# Mondol Knitwears Ltd (shed)

# Buildings Information

1. Single Storied Prefabricated steel shed.

# Observations

**Significant gap in connection**

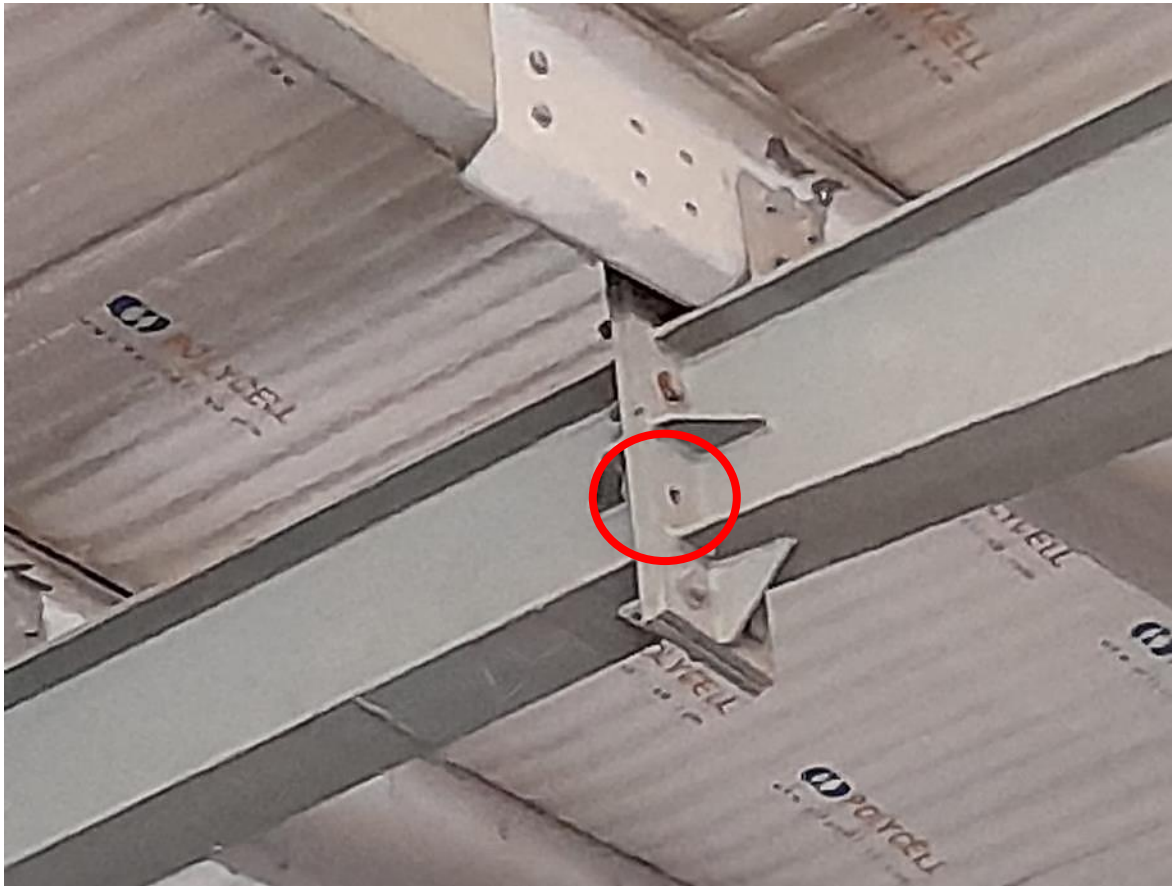
Connection gap in steel column-rafter joint

Connection gap in baseplate joint

Significant gap in the connection of the rafter to the column and base plate to the concrete pedestal was found. Building engineer is required to survey the whole structure & and identify the locations of the connection gaps and suggest proper remediation.
